AGREEMENT NO. CE 31/95
ENVIRONMENTAL IMPACT ASSESSMENT STUDY FOR
PWP ITEM NO. 437CL:
"ALDRICH BAY RECLAMATION - ENGINEERING WORKS"

ENVIRONMENTAL IMPACT ASSESSMENT FINAL REPORT

**Environmental Impact Assessment
Final Report
January 1997**

Figure 3.1

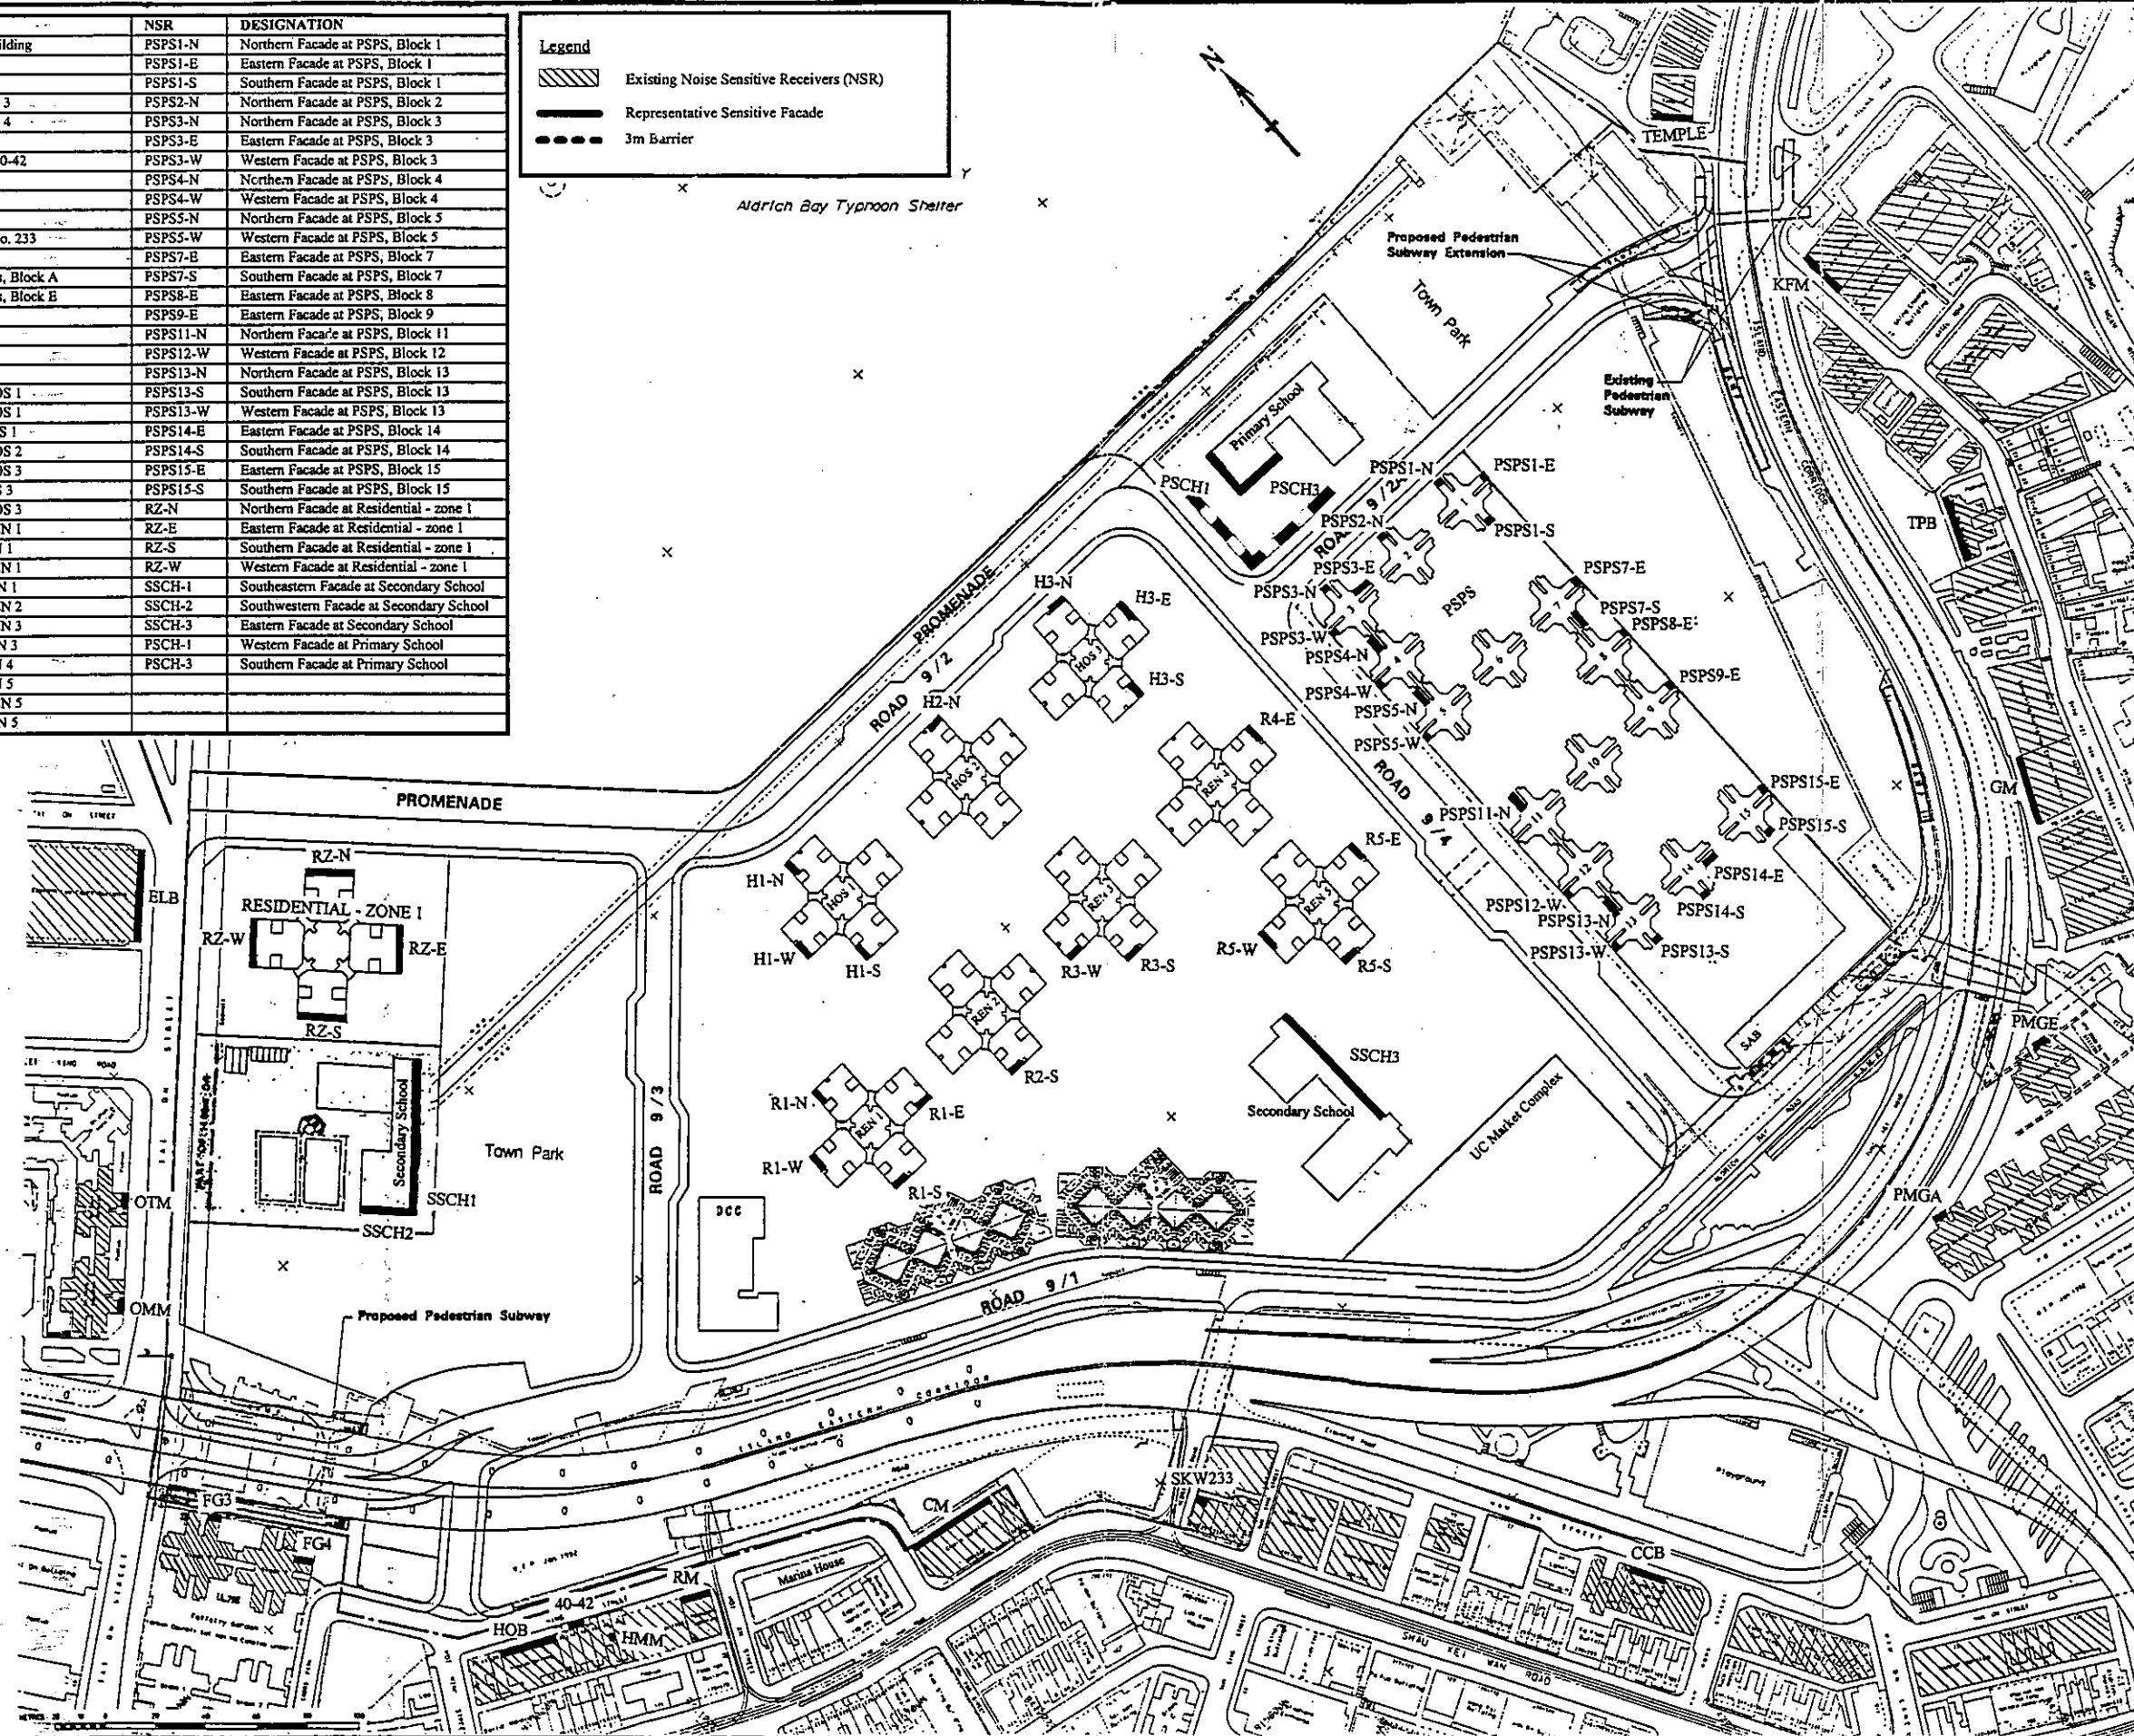
COMMENTS	RESPONSES
<p>3.3a) We cannot locate the temple and two schools in Figure 3.1. A table should be provided to list out all concerned NSRs with identification number, and Figure 3.1 and 3.3 should be aggregated into a figure. In addition to the existing NSRs in Figure 3.1, two existing schools located at A Kung Ngam Road and Tam Kung Mui Road should be included. Please ensure that the affected existing NSRs have been included in the assessment. Please ensure that the affected existing NSRs have been included in the assessment. Furthermore, we believe additional representative NSRs should be included as the proposed NSRs in Figure 3.3 cannot represent all existing NSRs in Figure 3.1.</p> <p>b) In addition to the marked NSRs in Figure 3.1, NSRs abutting Tai On Street should be taken into account in this assessment.</p> <p>3.4a) The main purpose of the construction noise assessment in this report is to avoid late focus on this issue. The onus is on the consultants to ensure the accuracy of the noise calculation. We would not check the noise calculation for construction phase, nor do we have any obligation to go through details of the assessment.</p> <p>b) It is the responsibility of the contractor to comply with the NCO and the relevant TMs if for any construction work during the restricted hours.</p> <p>3.5 The mitigated noise criteria should be presented in chapter 5.</p> <p>3.6a) Other traffic noise criteria, such as 65dB(A)L10 for school, should be included.</p> <p>b) Since para 3 has mentioned the noise insulation eligibility criteria, we suggest that the 3 ExCo criteria should be incorporated in this paragraph. The 3 criteria are :-</p>	<p>The temple and the existing schools at Ah Kung Ngam and Tam Kung Mui Road have been included in Figure 3.1. Furthermore, Figures 3.1 and 3.3 have been combined. Additional representative NSRs have been included in the noise impact assessment.</p> <p>Lei King Wan has been included in the noise impact assessment.</p> <p>Noted.</p> <p>Noted.</p> <p>Mitigated noise criteria have been presented in chapter 5.</p> <p>Noted. Please refer to the above comment.</p> <p>Noted. The three criteria have been included in this paragraph.</p>

<p>3.2 Page 10 para 9 Kai Fong Welfare Centre should be indicated in the Figure 3.1</p>	<p>Kai Fong Welfare Centre will be indicated in Fig. 3.1.</p>
<p>3.4 Page 19 para 2 I believe the noise levels at existing NSRs will exceed in the range of 1 - 14 dB(A) as the noise levels at FG4 is up to 84 dB(A) whilst the noise levels at planned NSRs will exceed in the range of 1 - 12 dB(A), Please revise.</p>	<p>Text will be revised.</p>
<p>3.5 Page 19 para 8 The noise levels contribution from new and existing roads should be indicated in this para.</p>	<p>Text will be added.</p>
<p>3.6 Page 20 bullet (e) "PSPS" should be amended as "HOS".</p>	<p>Text will be amended.</p>
<p>3.7 Page 20 bullet (f) "HOS" should be amended as "PSPS".</p>	<p>Text will be amended.</p>
<p>3.8 Page 20 bullet (g) a) The consultants should note that PSCH-2 and SSCH- are located at the school halls which are not considered as noise sensitive. Therefore, the assessment points should be deleted.</p>	<p>PSCH-2 and SSCH-4 will be deleted from assessment.</p>

Figure 5.5

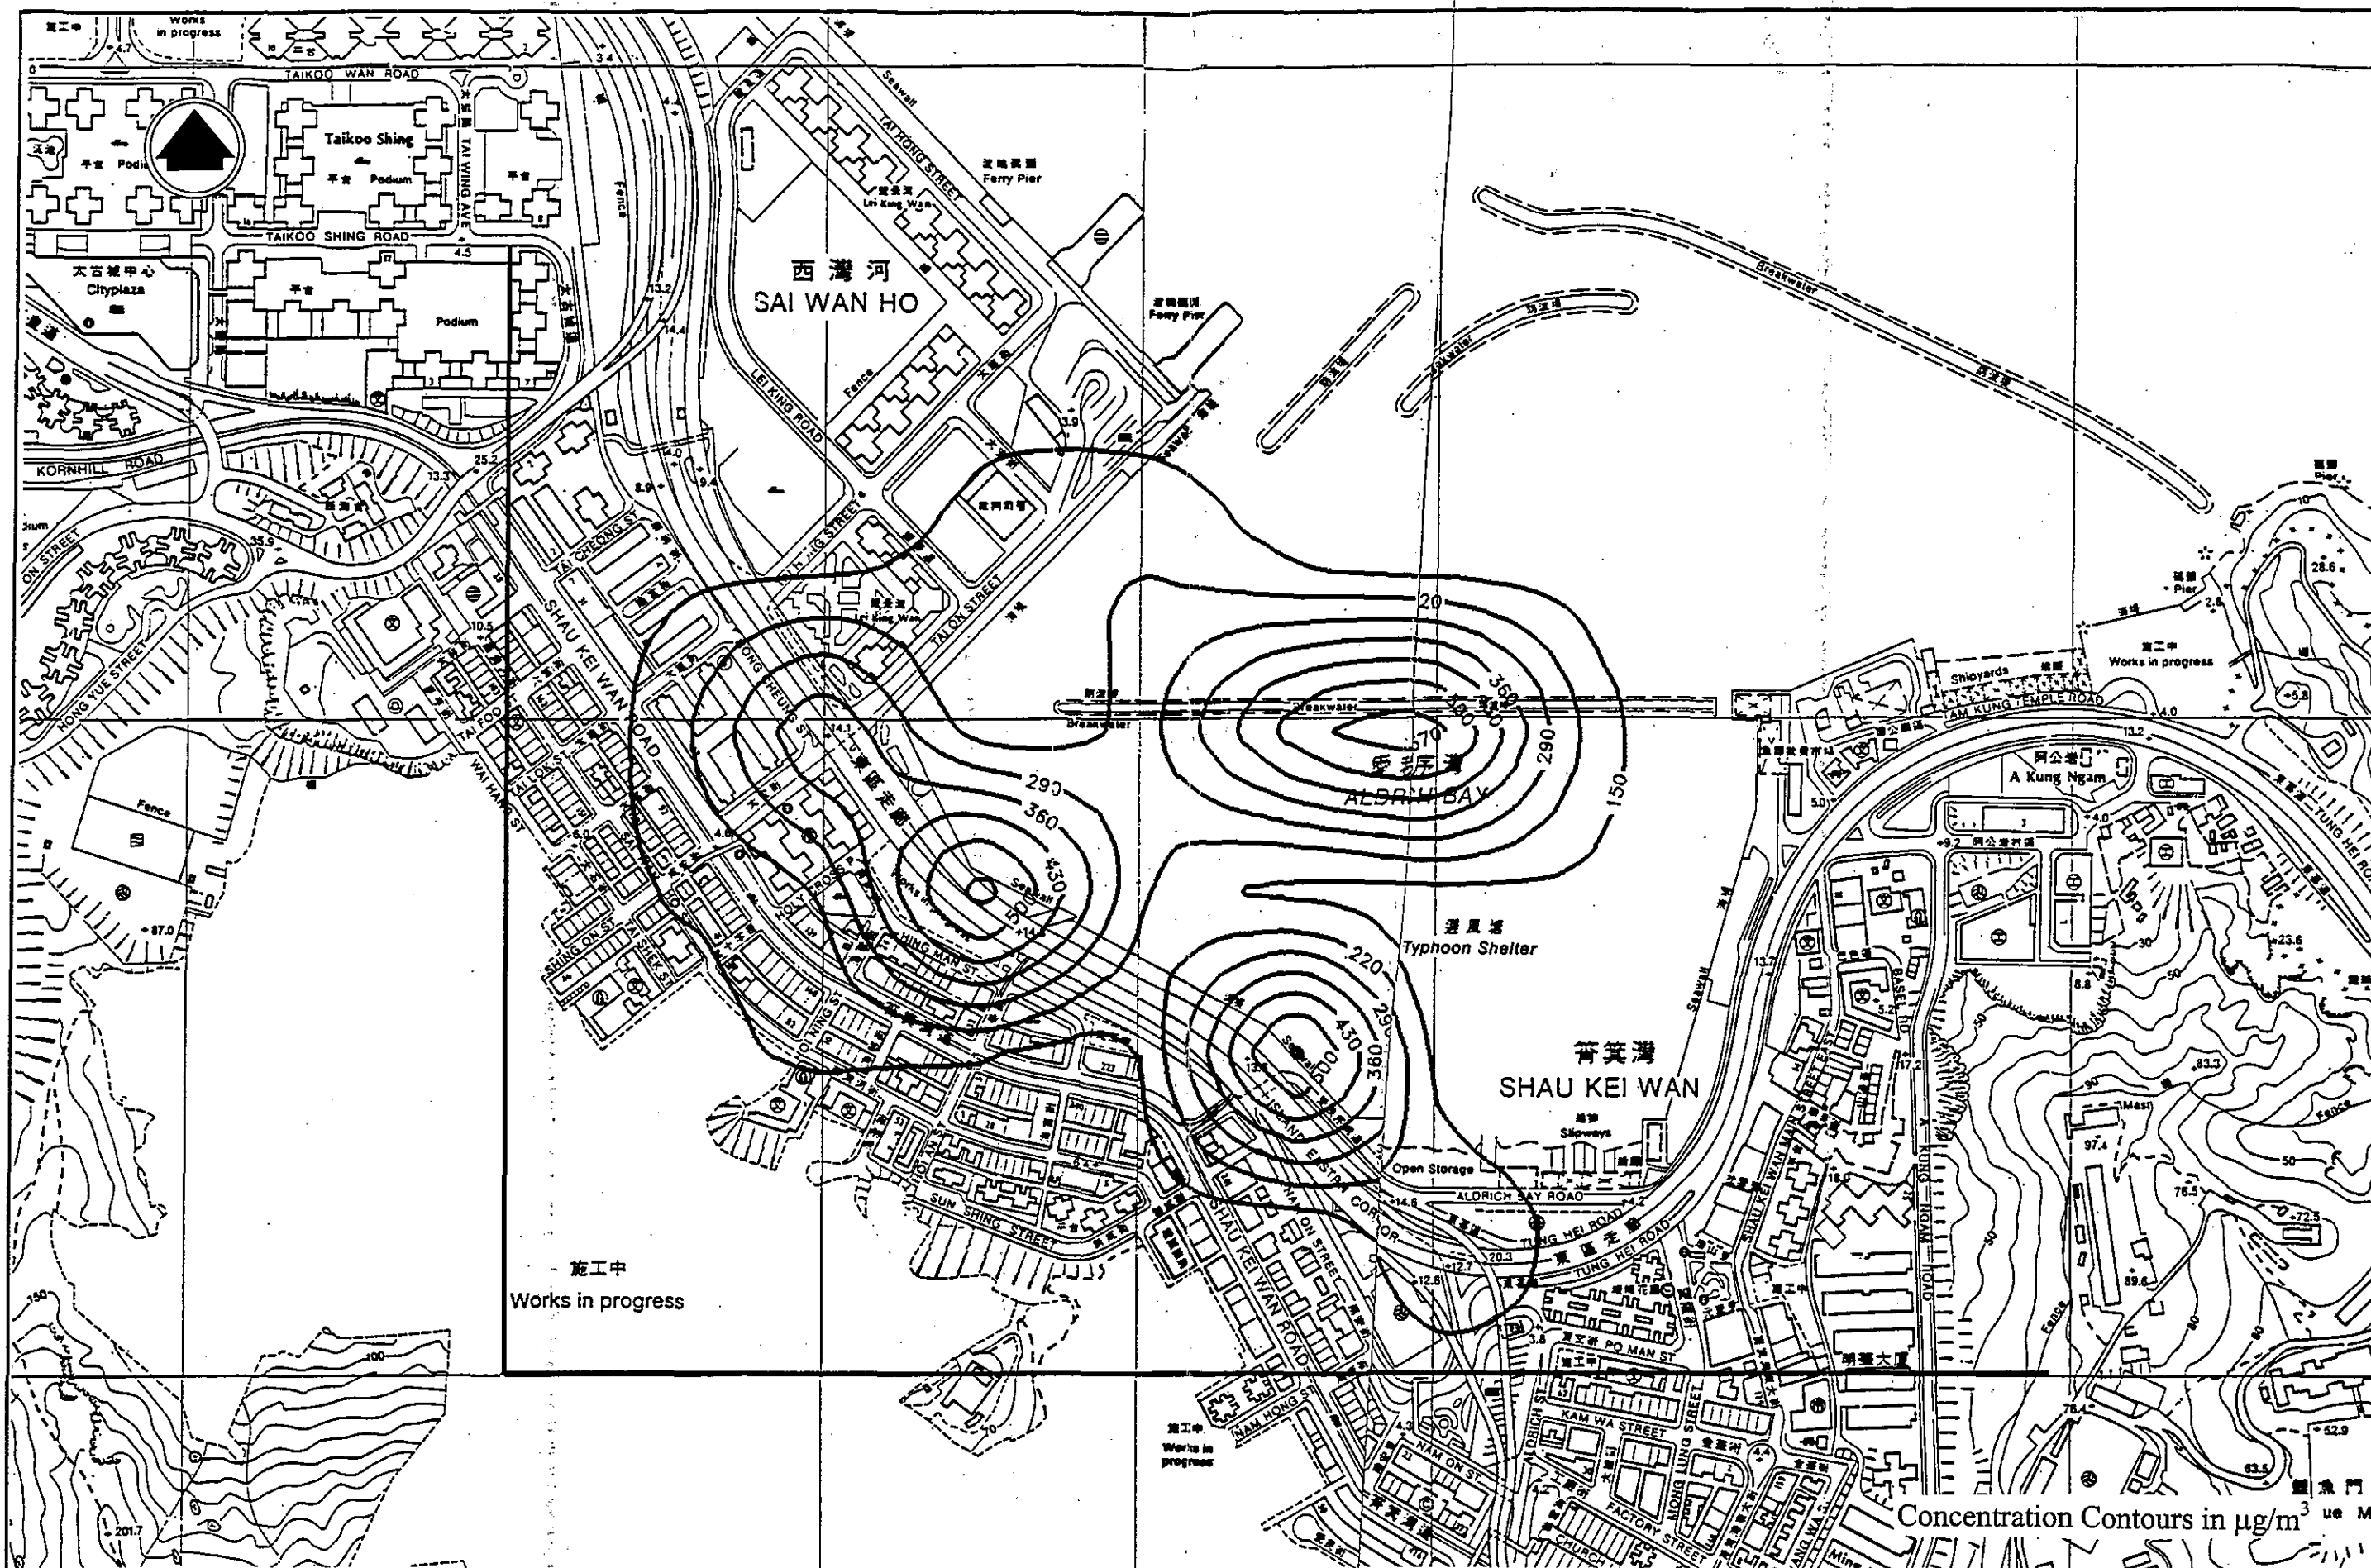
COMMENTS	RESPONSES
<p>Environmental Protection Department Ref. (14) in EP2/H9/07 VI</p> <p>2.1a) It is noted in Figures 5.3, 5.4 that mitigated 1-hour TSP level at some air receptors still exceed 1-hour TSP guideline level. However, no further mitigation measures are proposed though it was stated in the responses to comments that further mitigation measures have been included. The Consultant must propose further mitigation measures and verify their effectiveness by modelling.</p> <p>b) Figure 5.7 presented the cumulative 1-hour TSP level arising from Sections I, IV, V (mitigated), which shows that there is no exceedance of 1-hour TSP level. However, the mitigated 1-hour TSP level due to construction work in Section I alone (Figure 5.3) shows the 1-hour TSP level exceeds the 1-hour TSP guideline level at some air receptors. It seems that the cumulative dust impact due to Sections I, IV, V should also exceed 1-hour TSP guideline level if the impact due to Section I already exceeds the guideline level. Would the Consultants clarify?</p>	<p>Further mitigation measures will be proposed and be shown to be effective in the Final Report.</p> <p>Different dust suppression factors have been employed in the two calculations. Mitigation measures will be revised.</p>
